RE: Alden Resources, LLC., Area #6, Campbell County, Tennessee
OSM #3340 REVISION #6 APPLICATION-AS Built Certification for Pond #103

Alden Resources, LLC. Area #6 OSM #3340
Revision #6 Narrative
As Built Certification for Pond #103
Notification of Discontinuation of Mining

Alden Resources, LLC.
Area #6 OSM #3340
Pd 103 As Built

Scale: 1"=30'

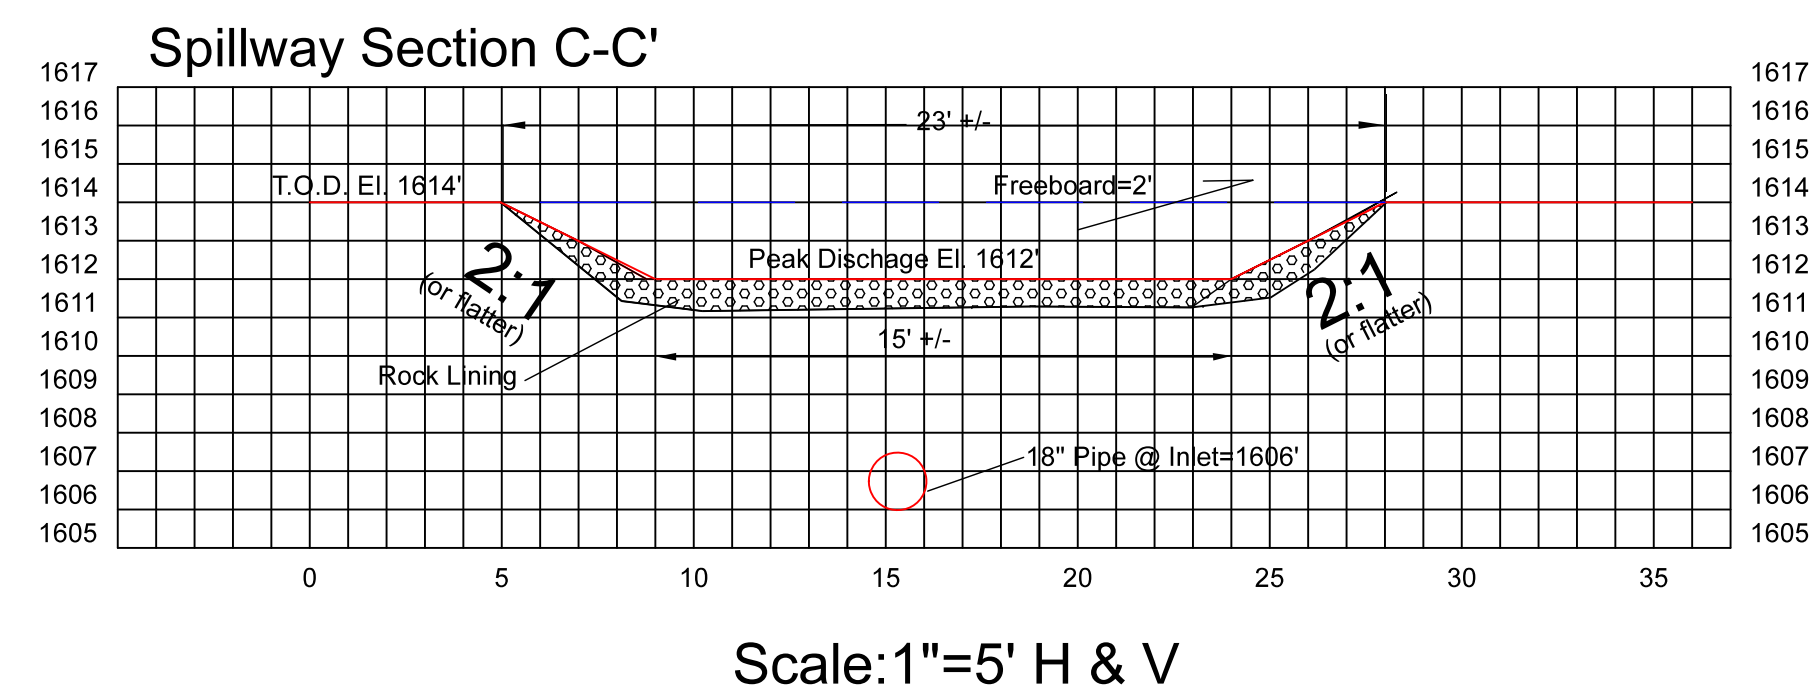
This revision is to complete the “as built” certification process for the above referenced pond. As discussed with OSM personnel on site, this revision also proposes to slightly increase the disturbed drainage area of pond #103 by about 2.1 acres. This small area captures the very end of the disturbance and eliminates the need to construct pond #104.

No additional mining will be done on this site once reclamation procedures are completed. Hence, pond #104 will remain on the map at its location even though its originally approved drainage area will be reduced by 2.1 acres which now will be contained in pond #103.

X The facility HAS NOT BEEN constructed in accordance with the design approved in this permit; or actual location or dimensions ARE NOT within accepted engineering tolerances for such facilities. (In this instance, submit 5 copies of a revision application with this certification).
